ADDENDUM NUMBER: #3

Project Name: Sharyland Water Supply Corp
New Building

Milnet Project No.: 217017

ADDENDUM #3

A7.2

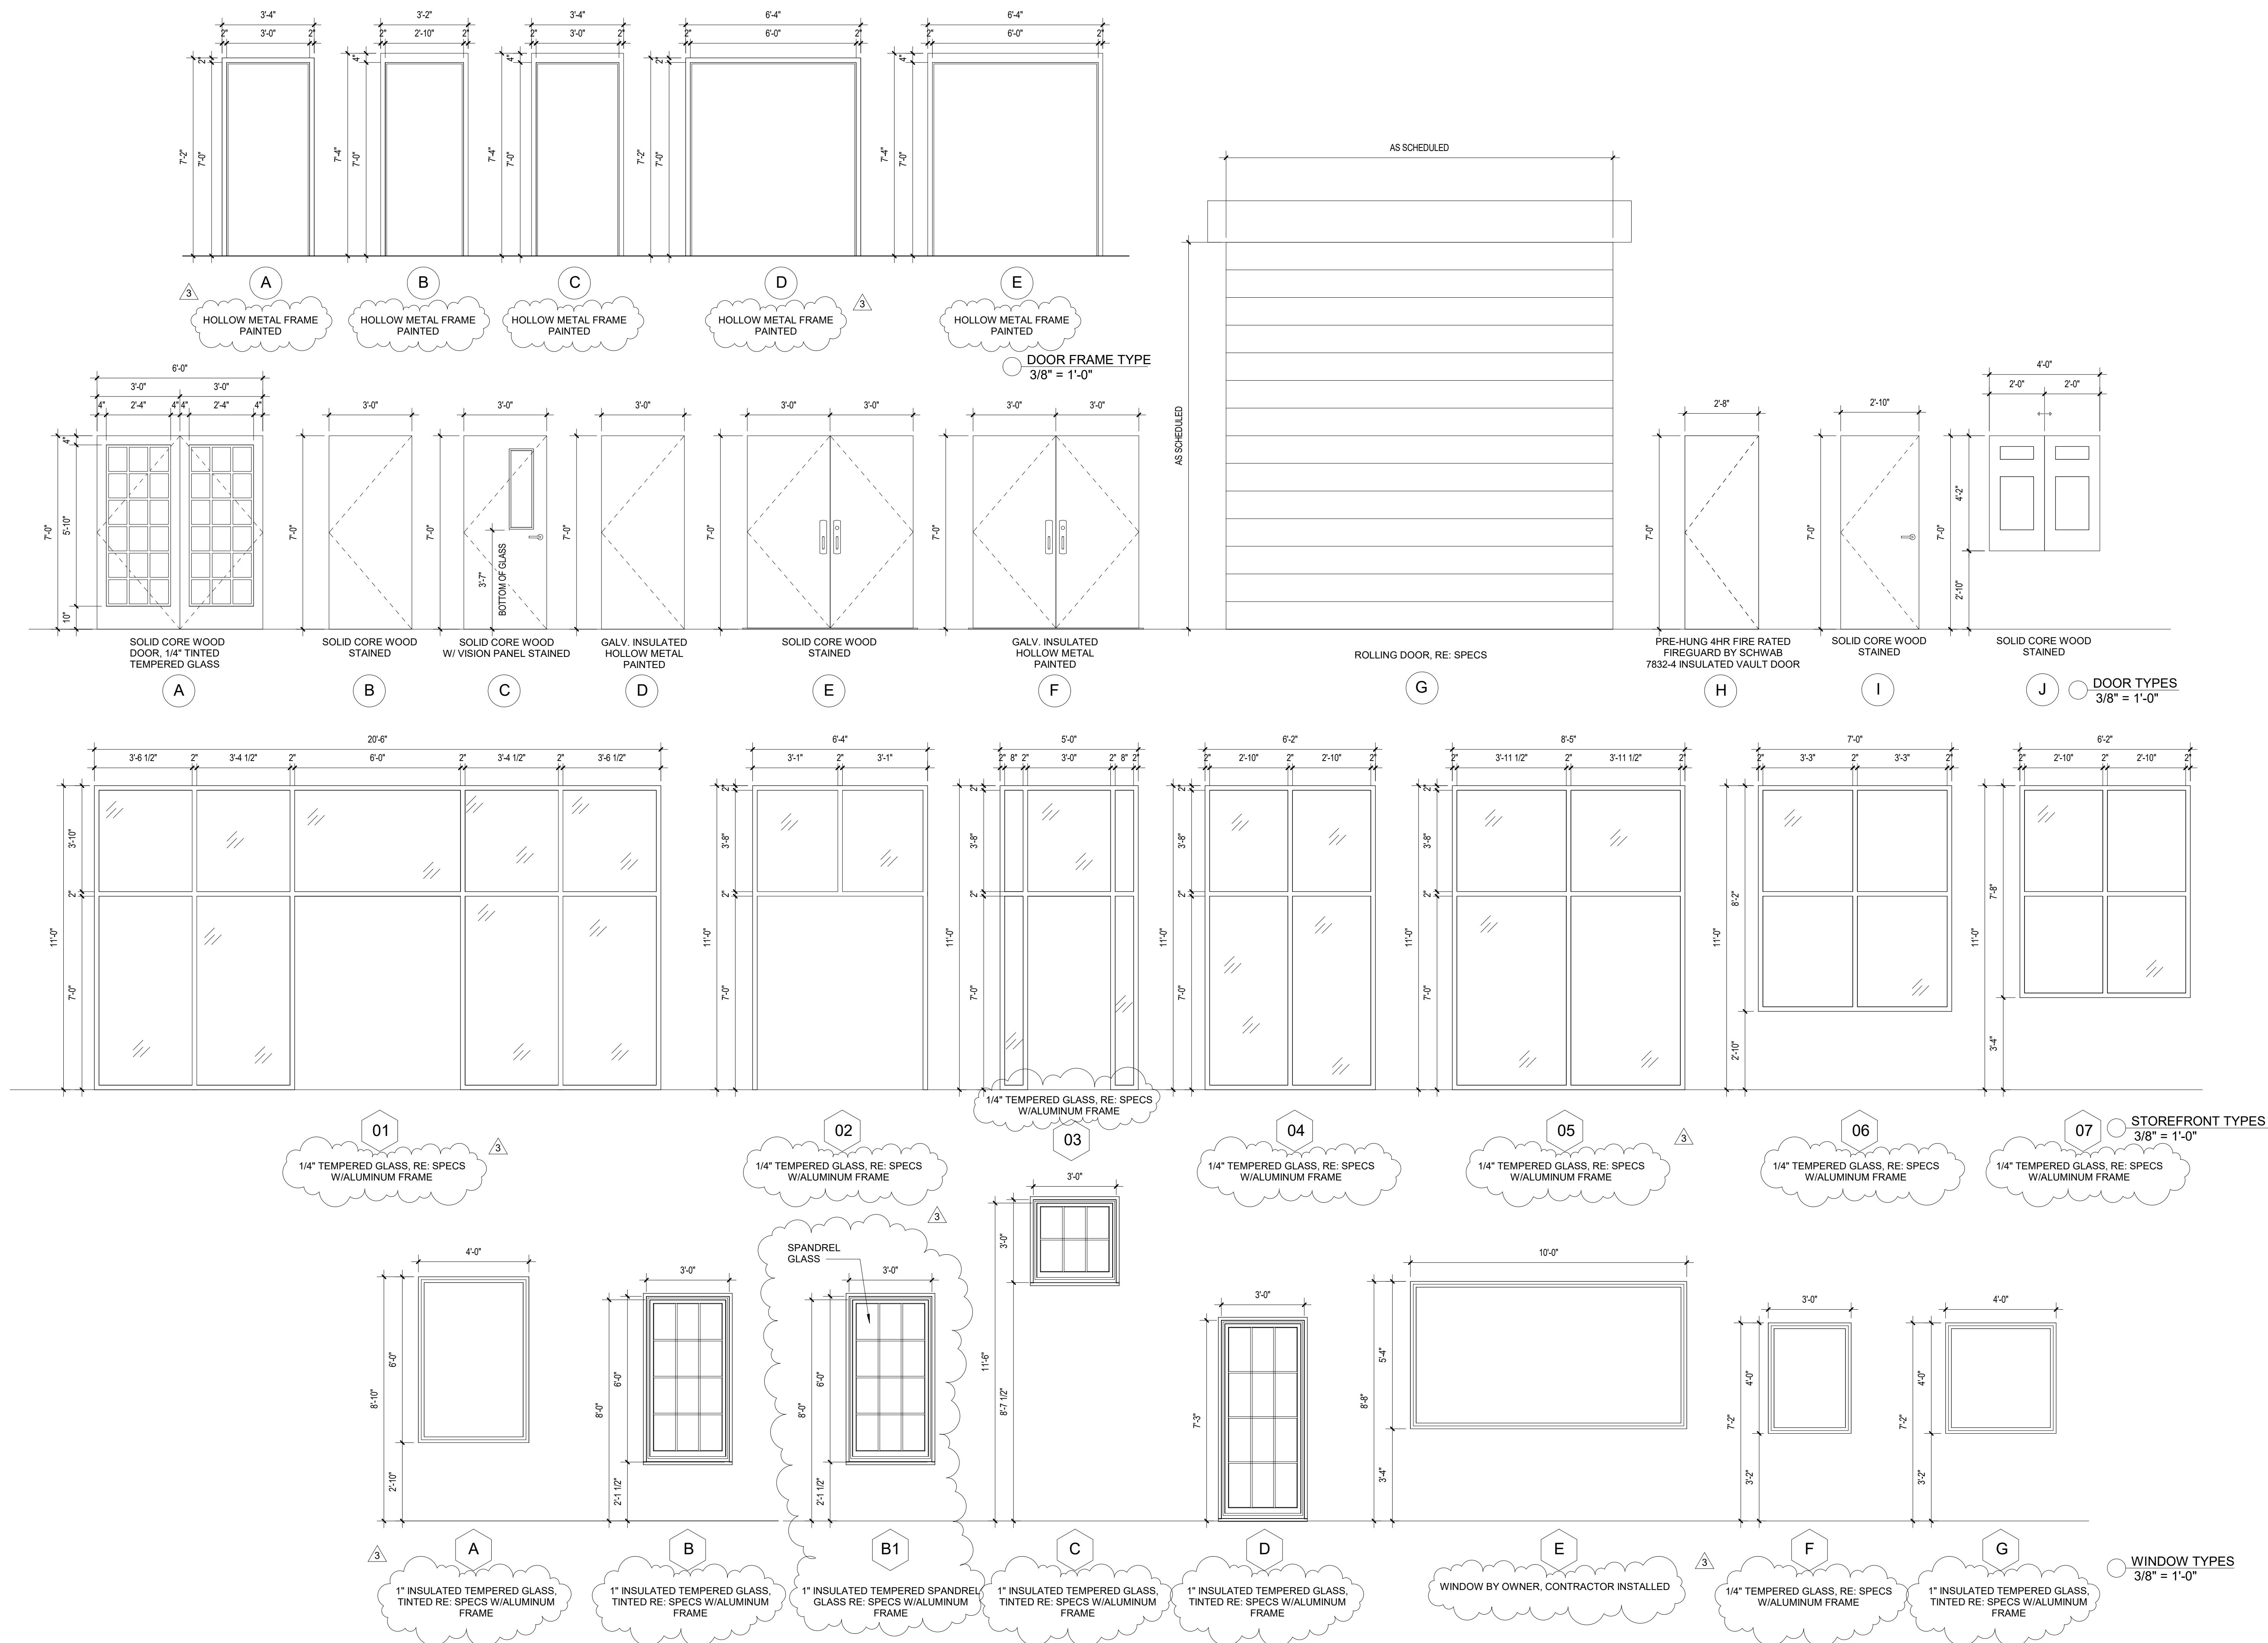
- 3.08 **Clarification:** Provide and install one (1) new window type B1.
Only Door No. 100, 100A, 102, 105, 106 and 107 shall have aluminum frames.
Refer to revised sheet A7.2

1 LIGHTING FLOOR PLAN
1/8" = 1'-0"

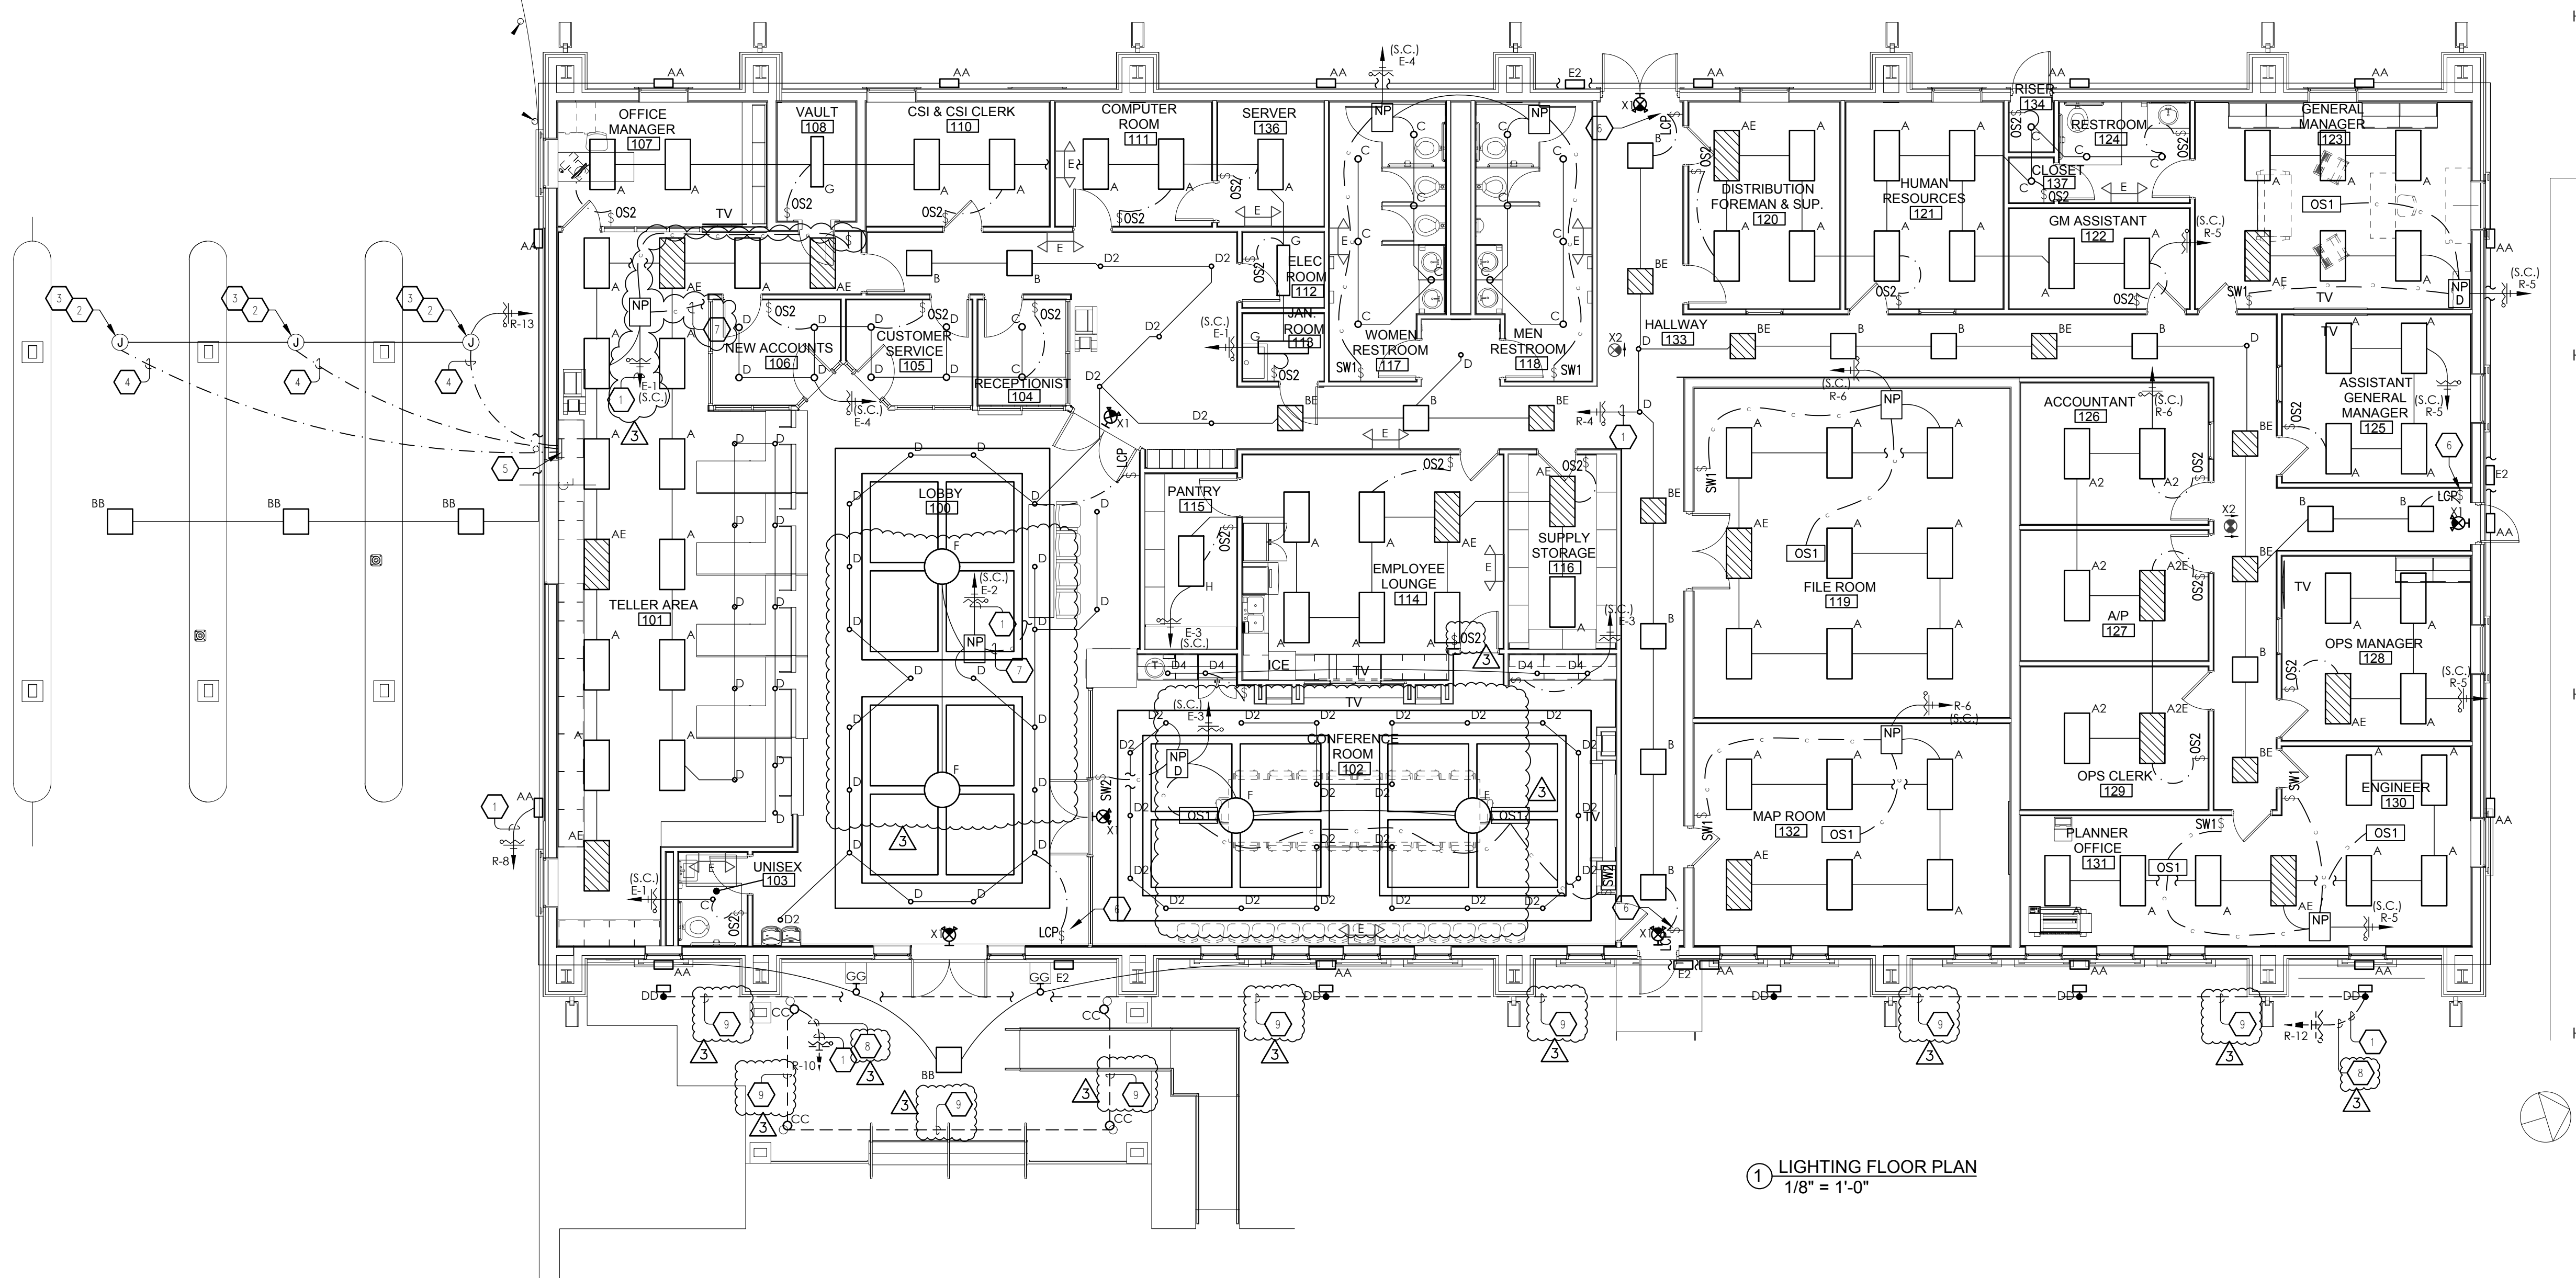
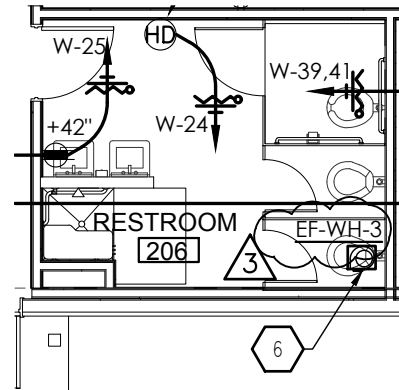
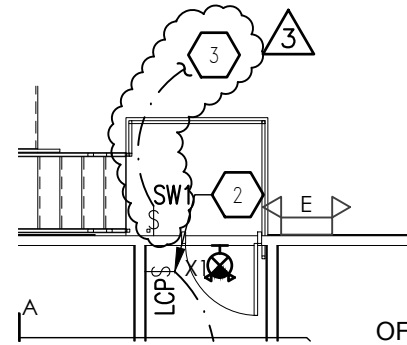
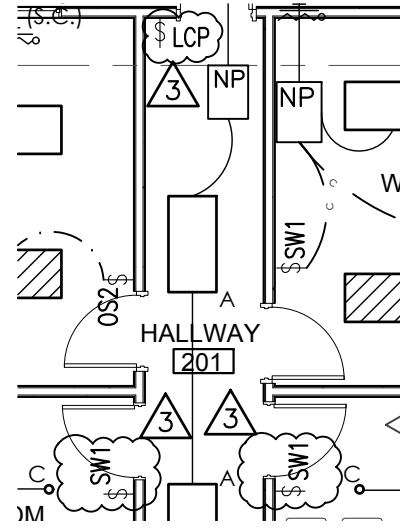
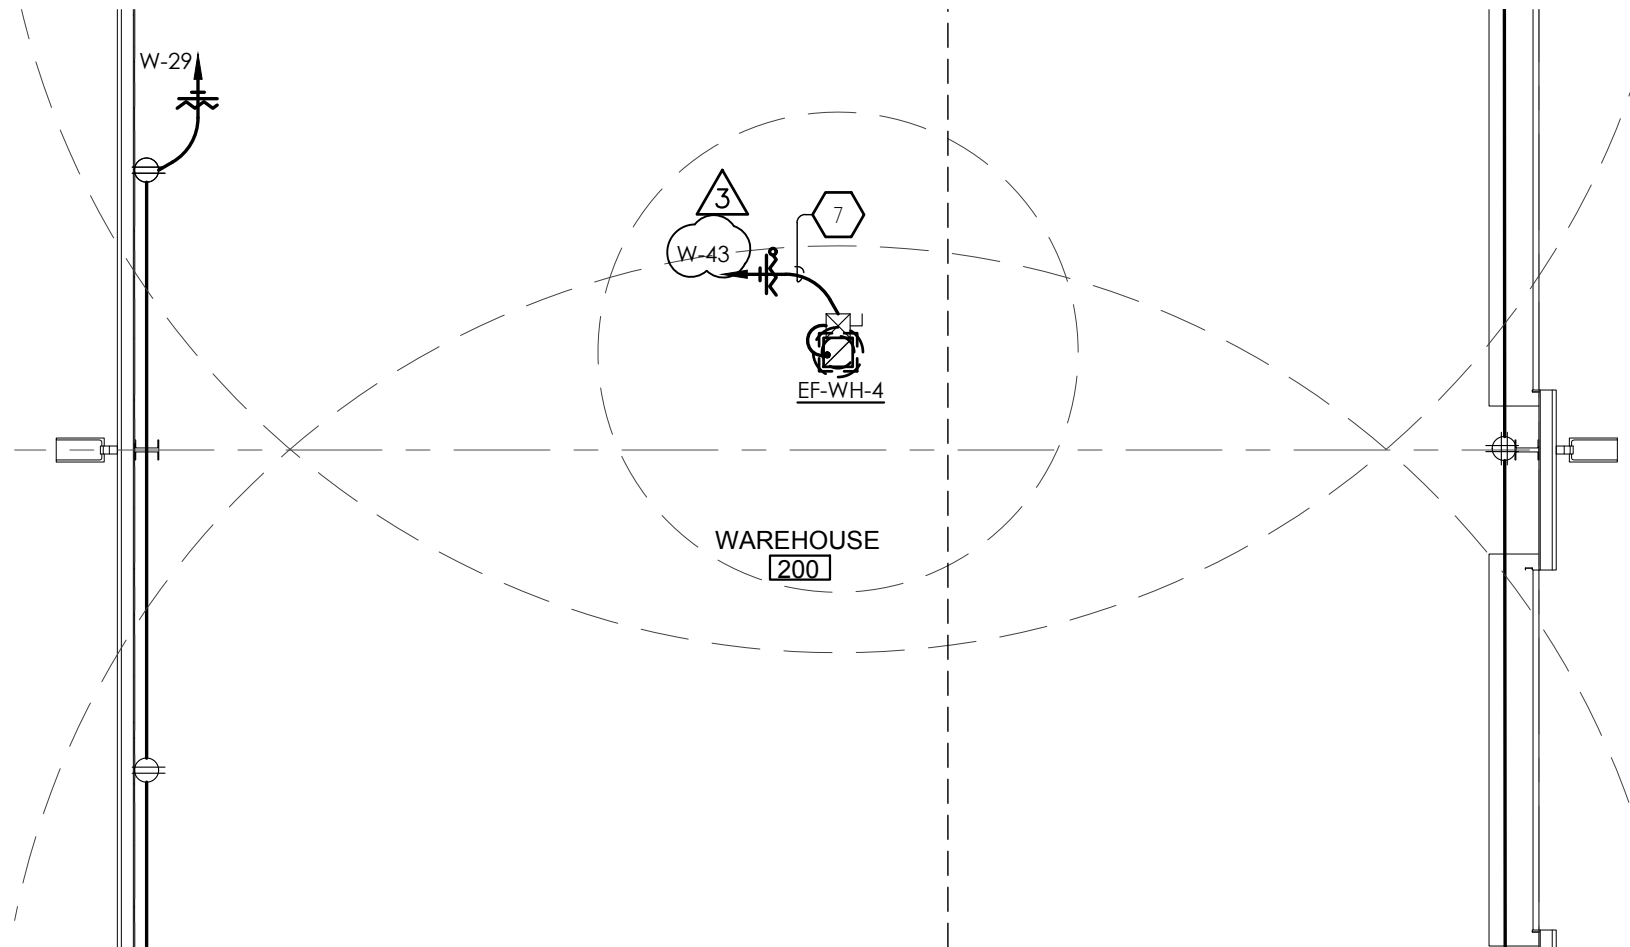
- I. Specifications:
 - A. Specification 263213 – Contractor shall provide fuel for 3/4 of the tank after all testing is done.
- II. General: N/A
- III. Mechanical:
- IV. Electrical:
 - A. Sheet AE1.0 – Revise lighting floor plan, refer to attached.
 - B. Sheet AE1.1 – Revise lighting, refer to attached.
 - C. Sheet AE2.0– Revise power plan, refer to attached..
- V. Plumbing: N/A
- VI. Fire Protection: N/A
